Access Compliance Report Public Rights-of-Way (Curb Ramps)

Main Street: ETHEREAL_RD Cross Street: SIENNA_PKWY Location: S

ADA ID: RPRK211104122520 Ramp Type: Type 1 - Perpendicular Initial Pass/Fail: Fail Overall Compliance: No Severity Score: 2

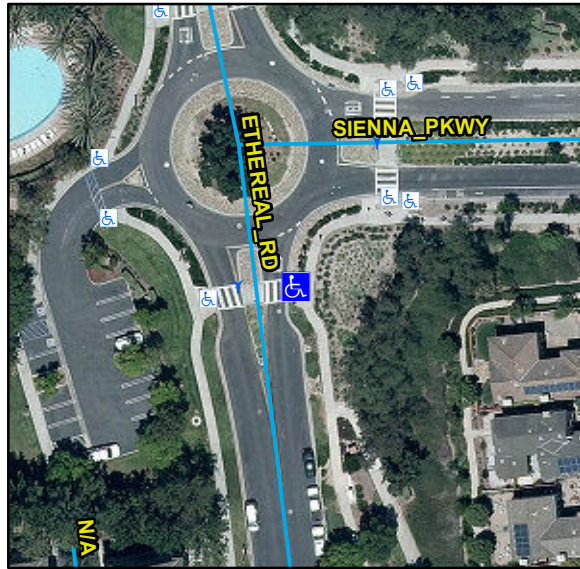
Compliance	Description	Data	Compliance	Description	Data
N/A	Ramp Length (in)	89	N/A	Flare Type LT	
Yes	Ramp Width (in)	48			N/A
Yes	Ramp Run Slope (%)	7	N/A	Flare Slope LT (%)	N/A
No	Ramp Cross Slope (%)	2.6	N/A	Flare Traversable LT	N/A
N/A	Landing Present	N/A	N/A	Flare Type RT	
N/A	Landing Length (in)	N/A			N/A
N/A	Landing Width (in)	N/A	N/A	Flare Slope RT (%)	N/A
N/A	Landing Run Slope (%)	N/A	N/A	Flare Traversable RT	N/A
N/A	Landing Cross Slope (%)	N/A	N/A	DWS Provided	N/A
N/A	Landing Movement Obstructed?	N/A	N/A	DWS Contrast	N/A
	Landing Movement Type	N/A	N/A	DWS Length (in)	N/A
N/A	Landing Shared	N/A	N/A	DWS Full Width	N/A
N/A	Clear Space	N/A	N/A	DWS Offset Left (in)	N/A
N/A	Clear Space To Crosswalk (in)	N/A	N/A	DWS Offset Right (in)	N/A
N/A	Marked Crosswalk 1	Yes	N/A	Marked Crosswalk 2	N/A
	Crossing 1 Direction	W		Crossing 2 Direction	N/A
	Marked Crosswalk 1 Width (in)	144		Marked Crosswalk 2 Width (in)	N/A

N/A	Ramp Inside Crosswalk 1	Yes	Yes	Ramp Inside Crosswalk 2	N/A
	Crossing 1 Slope (%)	2.2		Crossing 2 Slope (%)	N/A
	Crossing 1 Cross Slope (%)	2.6		Crossing 2 Cross Slope (%)	N/A
N/A	Gutter Ponding	N/A	No	Curb Slope	15.1
Yes	Gutter Lip Height (in)	0		Road Run Slope (%)	N/A
N/A	Gutter Run Slope (%)	N/A		Road Cross Slope (%)	N/A
N/A	Gutter Cross Slope (%)	N/A			
Yes	Overall Surface Condition: Acceptable		No	Perp Joint Present	No
	Cross Gutter Present?	No		Spandrel Present?	No
	Replace Cross Gutter?	N/A		Replace Spandrel?	N/A

Remove & Replace Entire Ramp.
